HISTORIC AND DESIGN REVIEW COMMISSION

June 19, 2019

HDRC CASE NO: 2019-304
ADDRESS: 338 MADISON ST
LEGAL DESCRIPTION: NCB 744 BLK 3 LOT 19 AND 20
ZONING: RM-4, HS, H
CITY COUNCIL DIST.: 1
DISTRICT: King William Historic District
LANDMARK: Berman / Kinder House
APPLICANT: Russell Boothe/BOOTHE BROTHERS PAVING CO II LP
OWNER: Russell Boothe/BOOTHE BROTHERS PAVING CO II LP
TYPE OF WORK: Window replacement on rear accessory structure, front yard fencing, and rear screened porch
APPLICATION RECEIVED: May 20, 2019
60-DAY REVIEW: July 19, 2019
CASE MANAGER: Huy Pham
REQUEST:

1. Replace 14 wood windows on a non-historic accessory structure with matching wood windows.
2. Install cedar screening to the existing rear porch.
3. Install wrought iron front yard fencing.

Back porch
screen, and cedar.

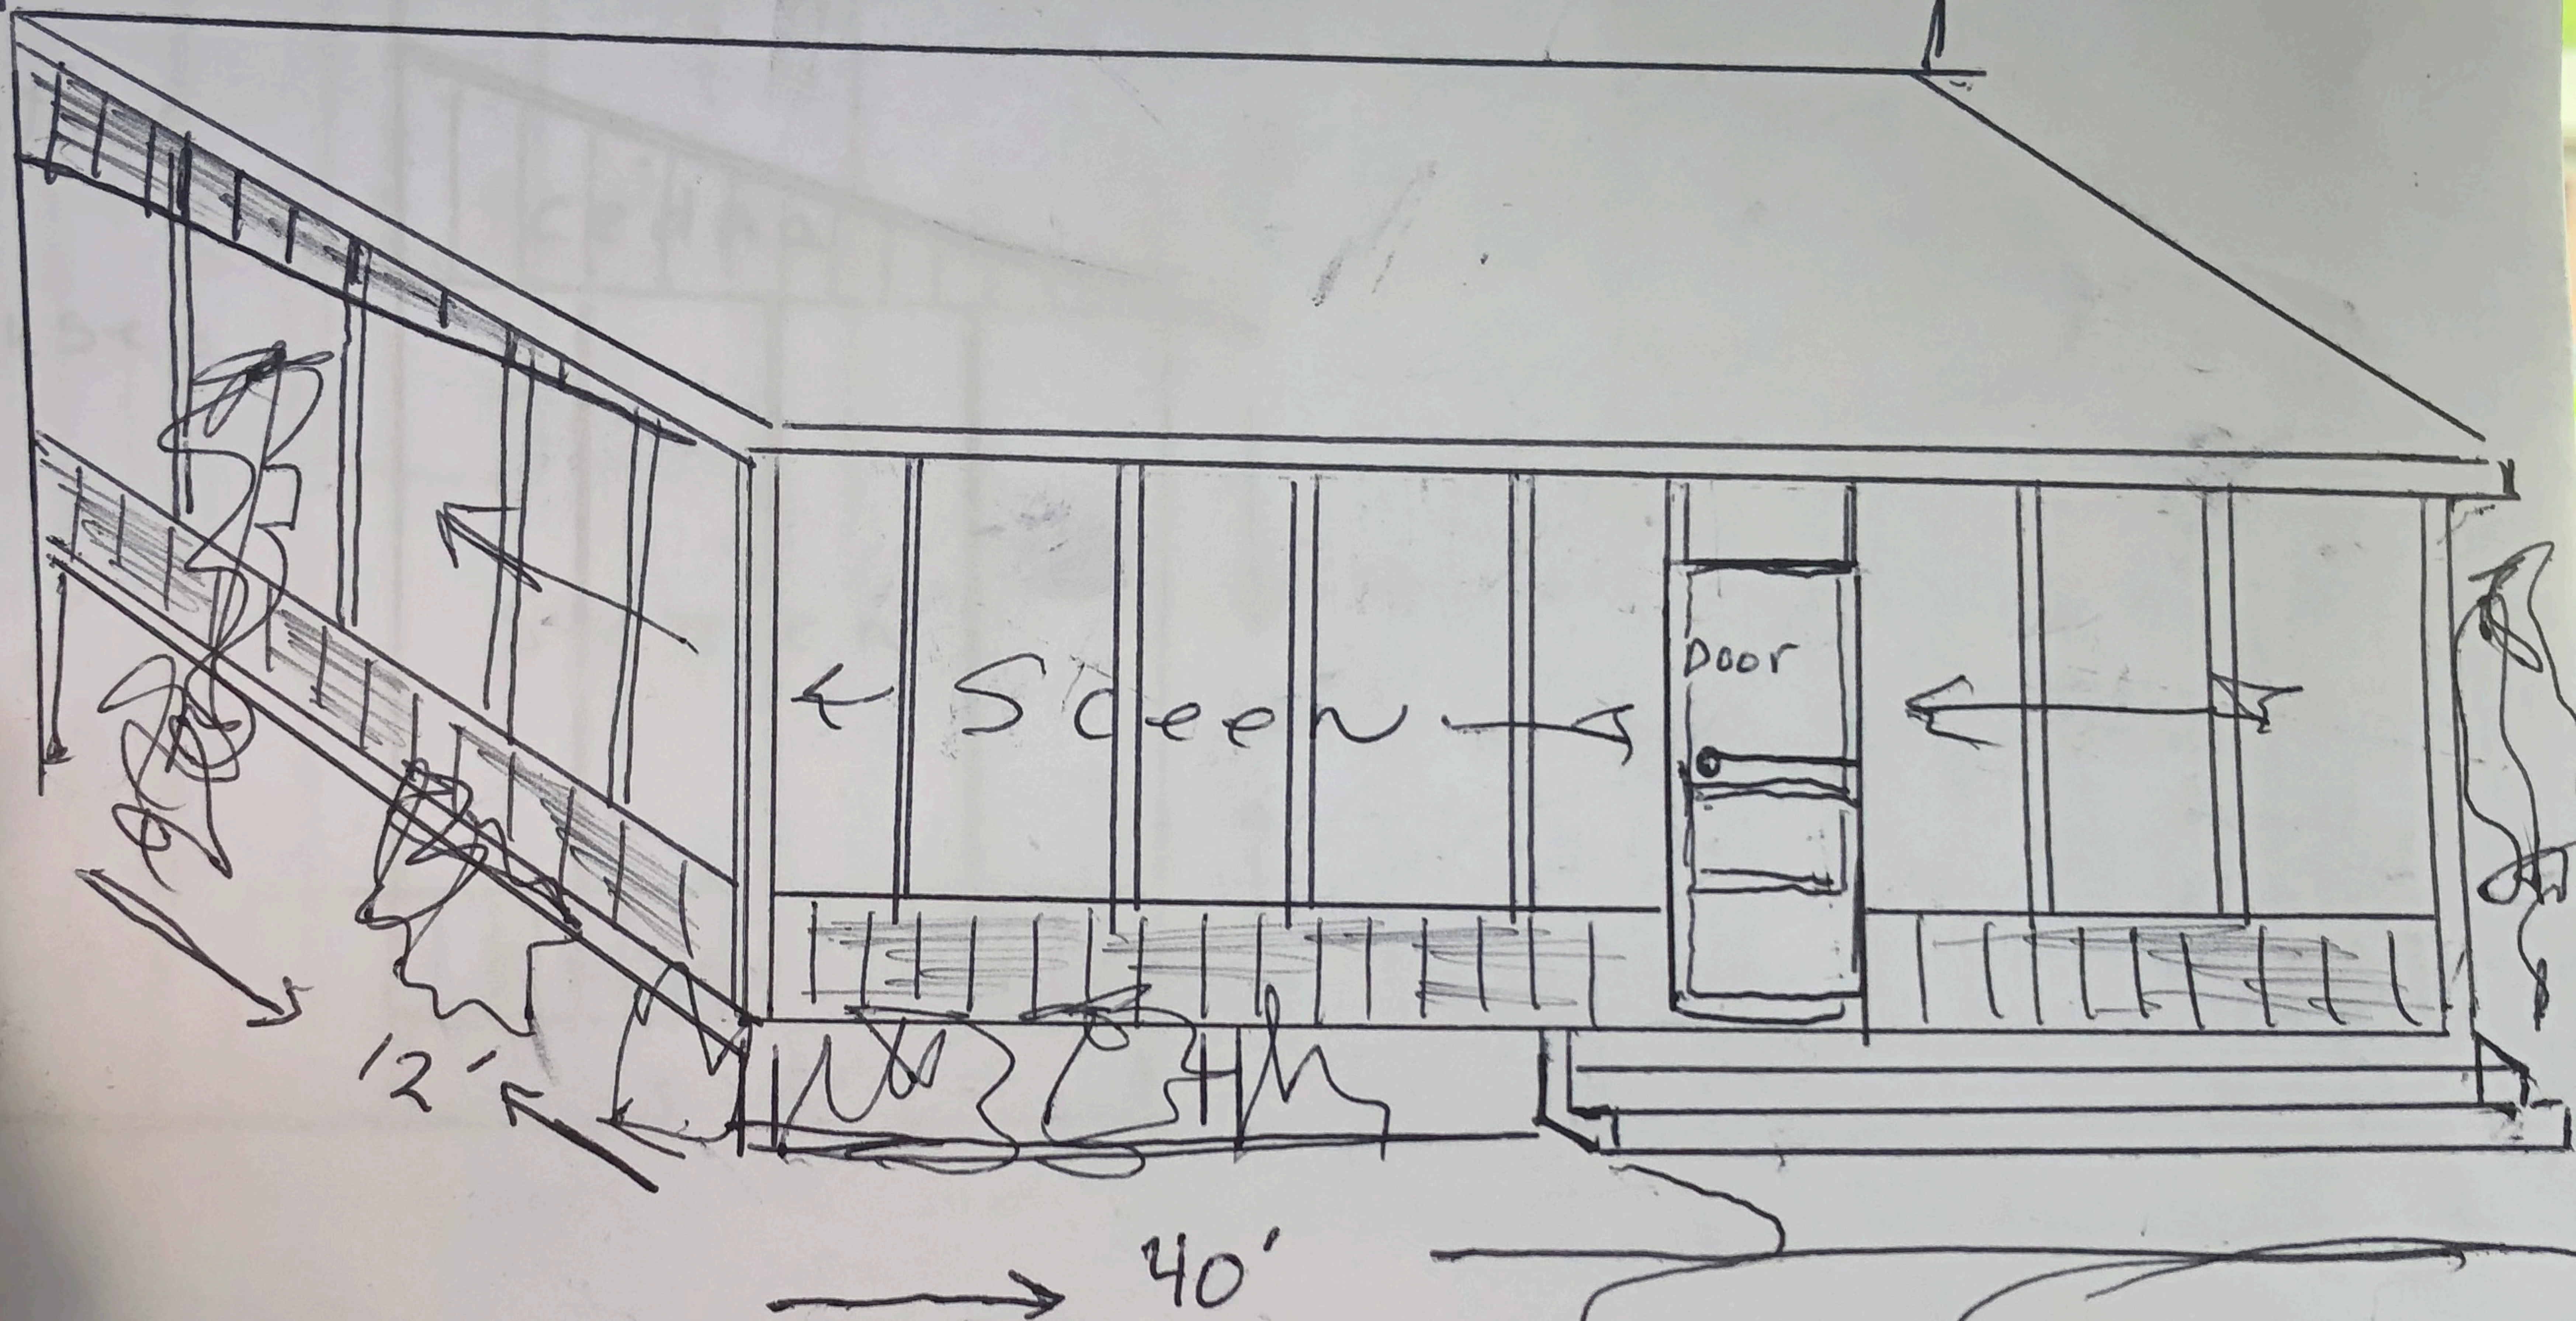
- iii. SCREENED PORCH – The applicant has proposed to install a screened porch addition onto an existing non-original rear wood deck. The screened porch is to feature vertical cedar siding with a shed roof with matching roofing materials as the primary structure. The porch features 12' in depth, 40' in width, and a 10' ceiling height. Staff finds that the general massing, form, size, and materials are generally consistent with the Guidelines for Additions. However, a complete measured drawing should be submitted to staff for final approval.

- ii. That the applicant submit dimensioned construction documents for the screened porch that are consistent with the Guidelines to staff for review and approval prior to the issuance of a Certificate of Appropriateness.

Fence.

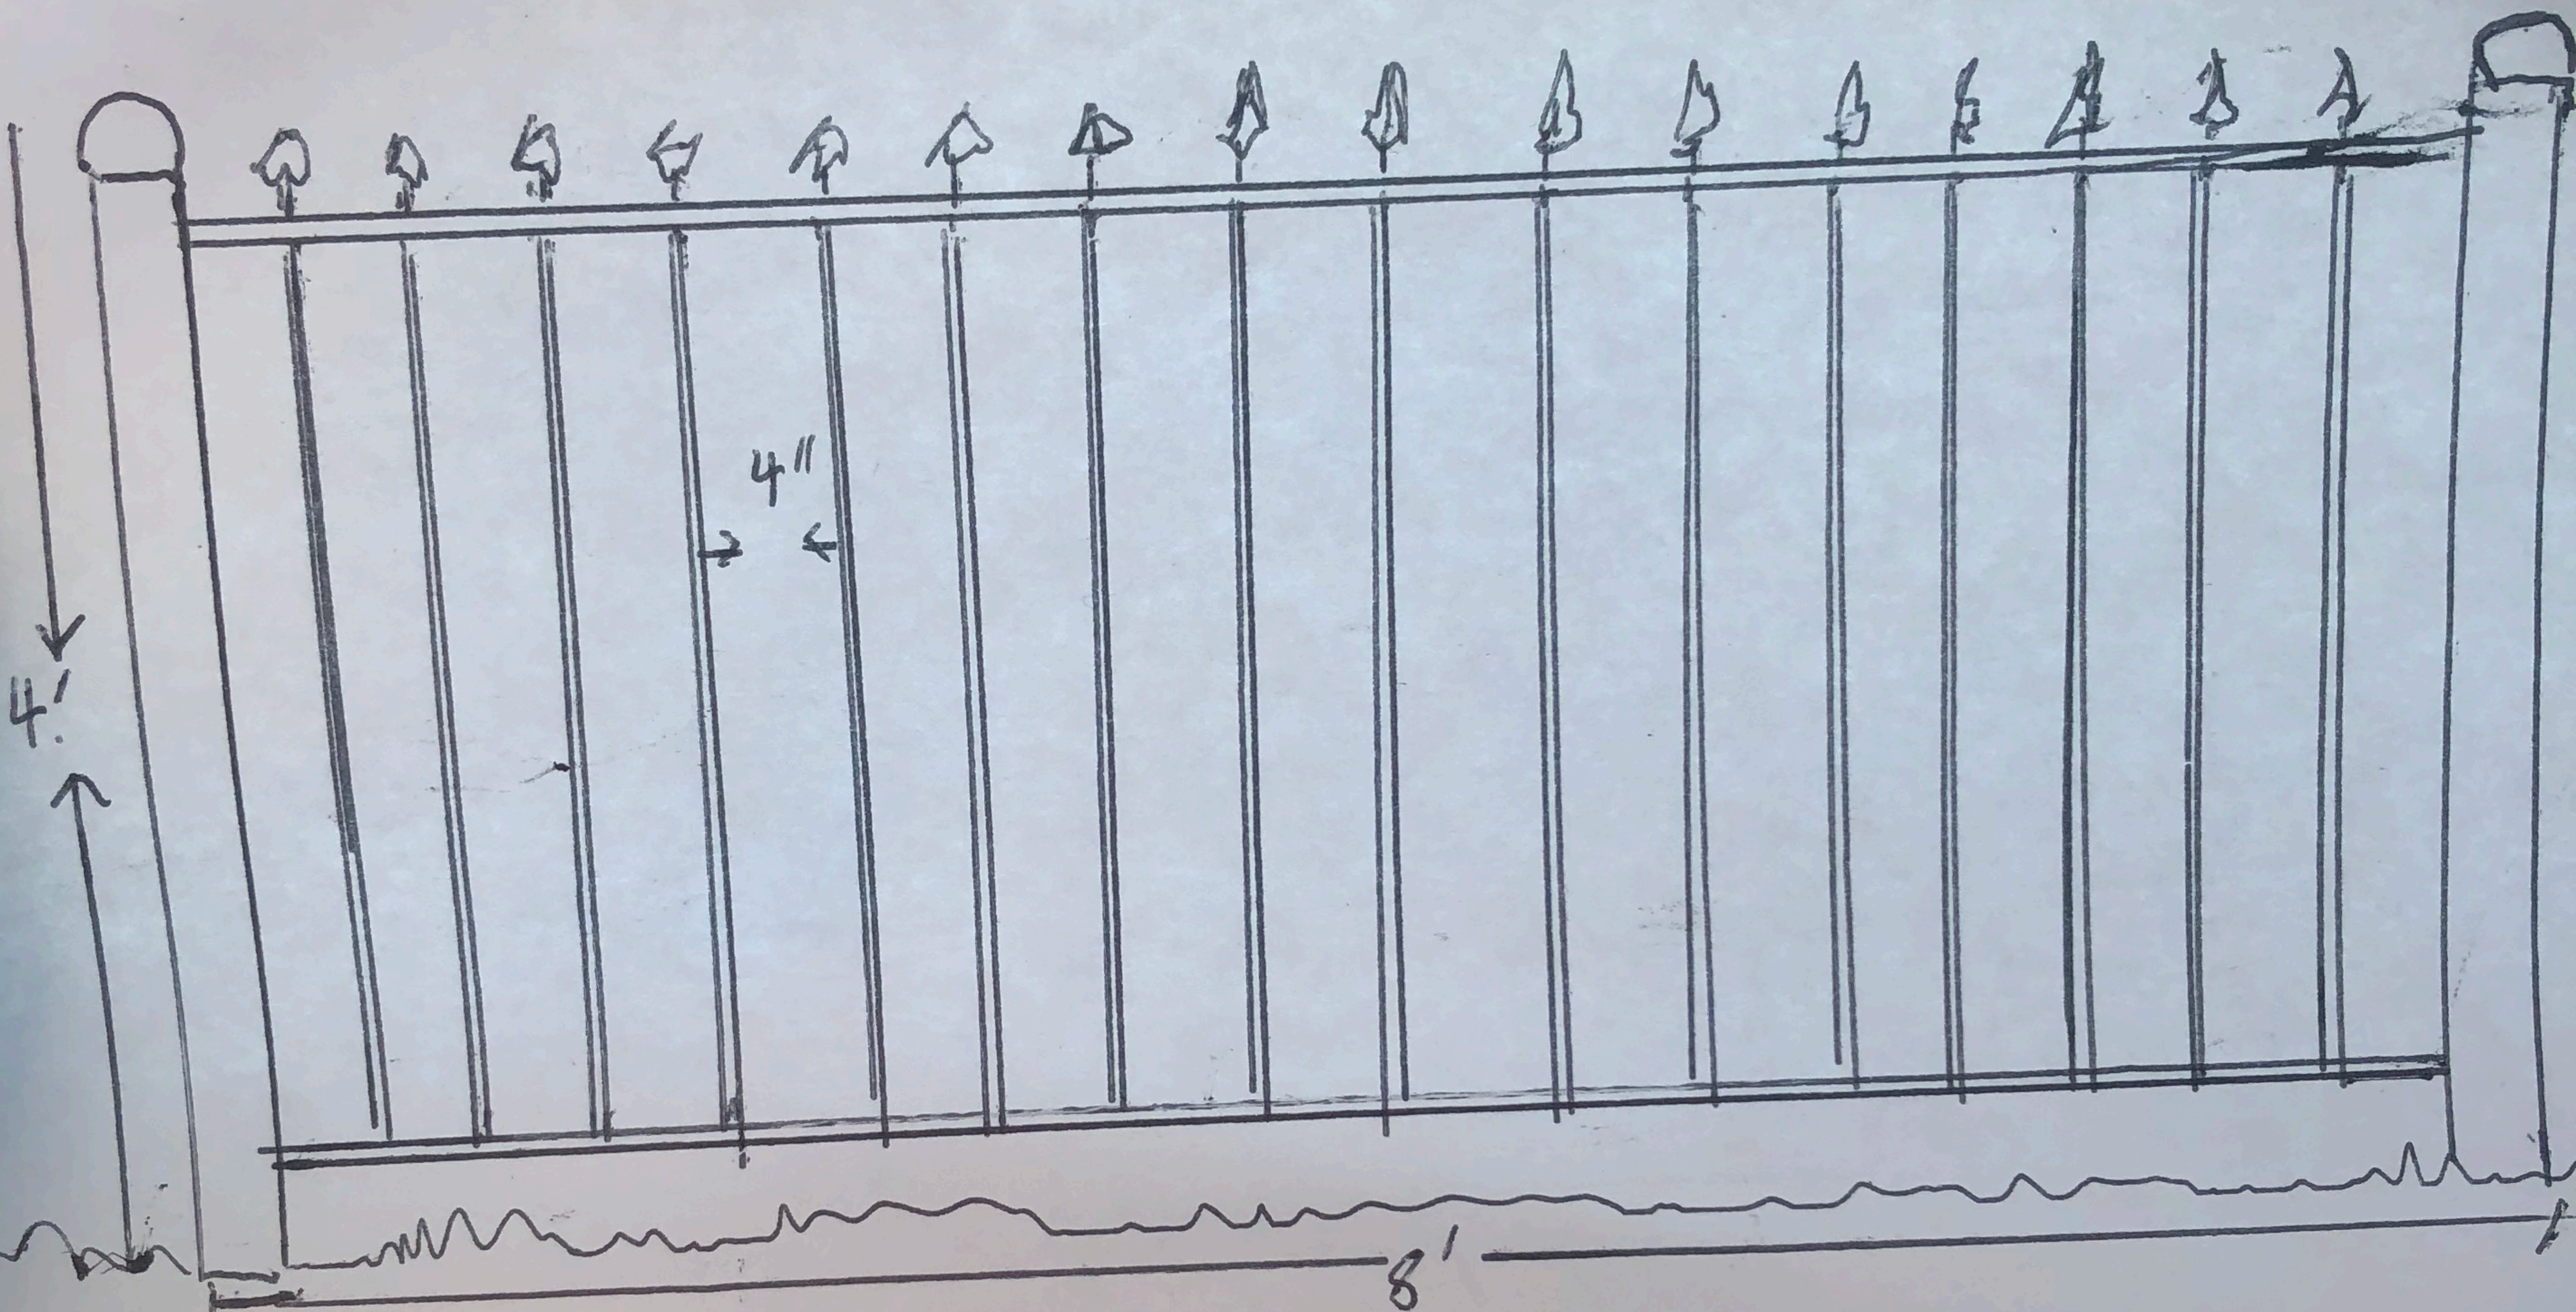
- iv. FRONT YARD FENCE – The applicant has proposed to install a wrought iron front yard fence at four feet (4') in height.
- v. LOCATION – Per the Guidelines for Site Elements 5.2.B.ii., front yard fences should not be introduced in a location that did not historically have them. Staff finds that fences are present on the other three properties at the intersection of Madison and E Sheridan, and the immediate block within the King William Historic District.

- vi. HEIGHT – The Guidelines for Site Elements 5.2.B.iii., front yard fences should be limited to a maximum of four feet (4') in height. Staff finds that the proposed height is appropriate.

materials of the house or main structure. Staff finds that the proposed wrought iron fence is appropriate to the style of the structure and relates to other fences of similar design in the immediate vicinity.

- iii. That no portion of the front yard fence exceed four (4) feet in height.

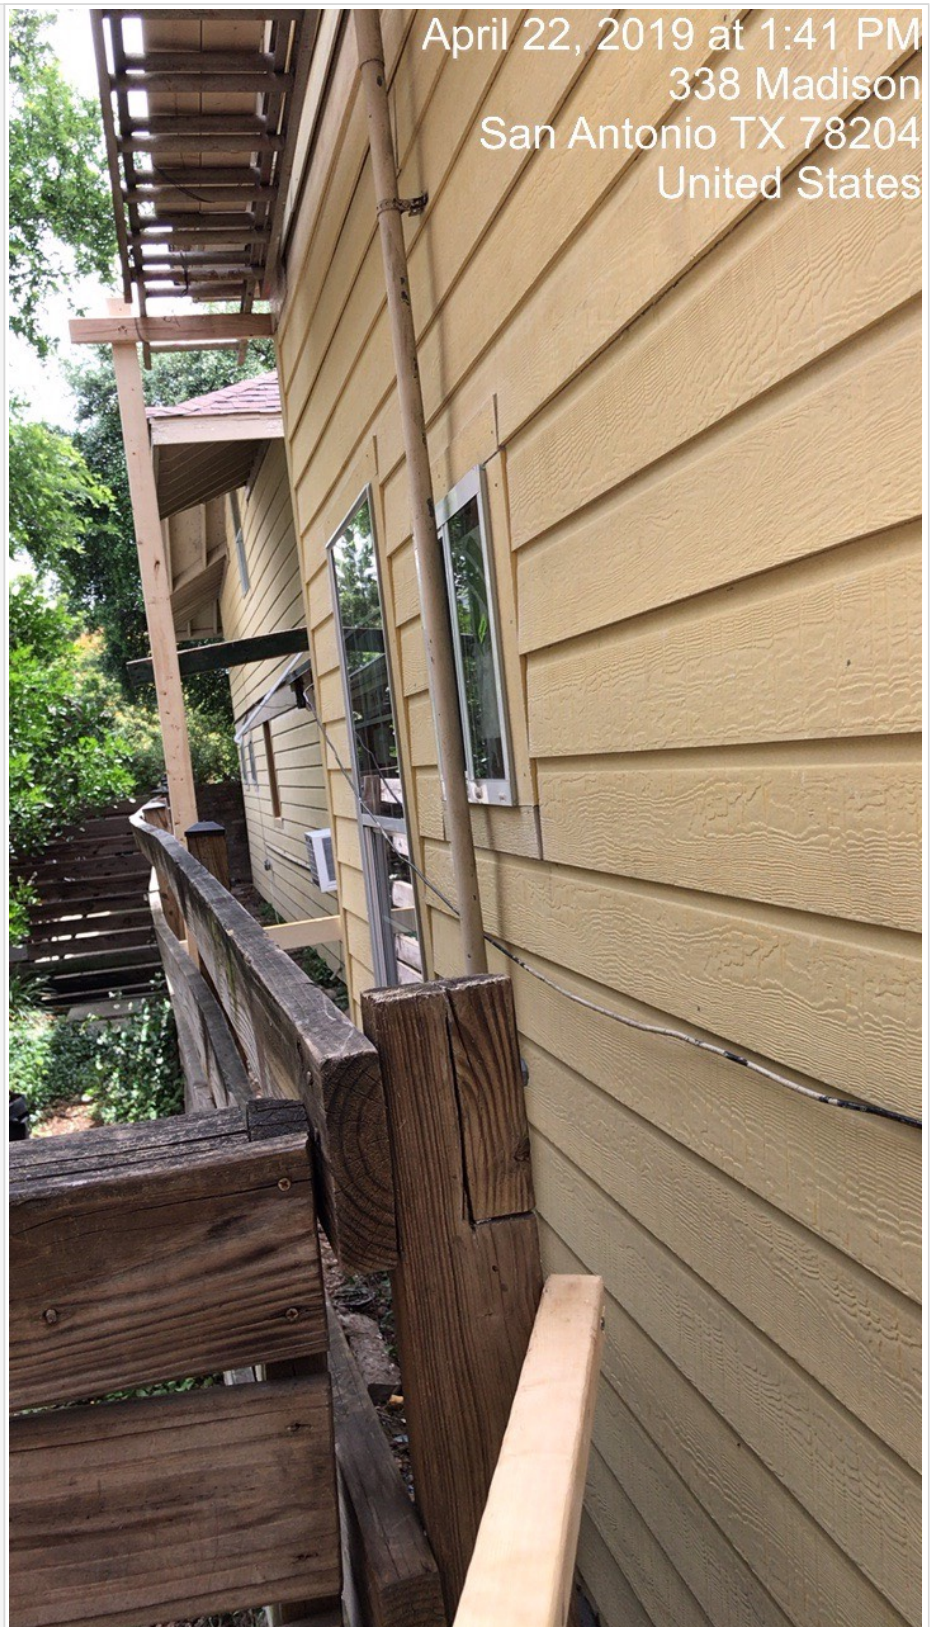
Date	04/22/2019
Time	01:45 PM (-5 GMT)
Context	citizen report
Present Staff	Huy Pham
Present Individuals	Contractor(s)
Types of Work Observed	Exterior Maintenance and Alterations
Amount of Work Completed	75%
Description of work	Window replacement on rear accessory structure with vinyl windows will faux divided lights. At least 6 window sashes were visible in the truck bed in the rear driveway.
Description of interaction	Two landscape contractors were on site. One gave access to the rear yard and will forward the violation notice to the homeowner. Staff advise the contractor to not discard the original window sashes until approved is issued.
